Project	IEEE 802.16 Broadband Wireless Access Working Group < http://ieee802.org/16 >	
Title	Enhancement for rate 2, 4-transmit antenna STC	
Date Submitted	2004-11-04	
Source(s)	Jianzhong (Charlie) Zhang, Kiran Kuchi, Anthony Reid, Nico Van Waes	Voice: 972-374-0958, 972-374-1862 Fax: 972-894-5937 charlie.zhang@nokia.com , kiran.kuchi@nokia.com
	Nokia 6000 Connection Drive Irving, TX 75039	
Re:	IEEE 802.16e D5 Draft	
Abstract	Proposes an enhancement to rate 2, 4-transmit antenna space time code	
Purpose	To incorporate the changes proposed here into the 802.16e D5 Draft.	
Notice	This document has been prepared to assist IEEE 802.16. It is offered as a basis for discussion and is not binding on the contributing individual(s) or organization(s). The material in this document is subject to change in form and content after further study. The contributor(s) reserve(s) the right to add, amend or withdraw material contained herein.

Enhancement for rate 2, 4 transmit antenna STC

Figure1: FER performance of circulated matrix B

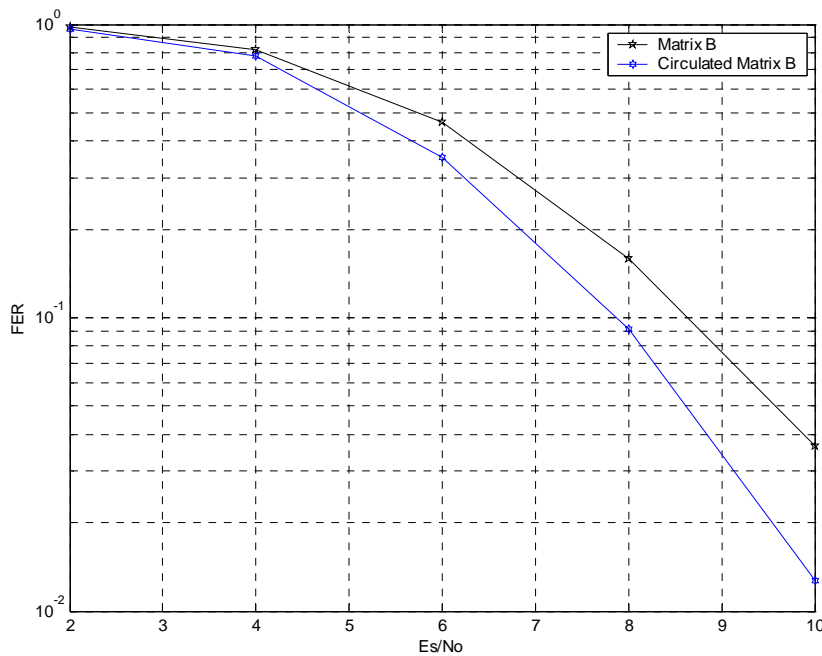
In Figure 1, we compared the FER performance of the circulated code to Matrix A for 4 Tx and 2 Rx case in for Ped A channel, rate 1/2 convolutional code, QPSK modulation using LMMSE receiver. We notice an increase in coding gain up to 1.0 dB. Similar gains are expected for other modulation and coding modes.
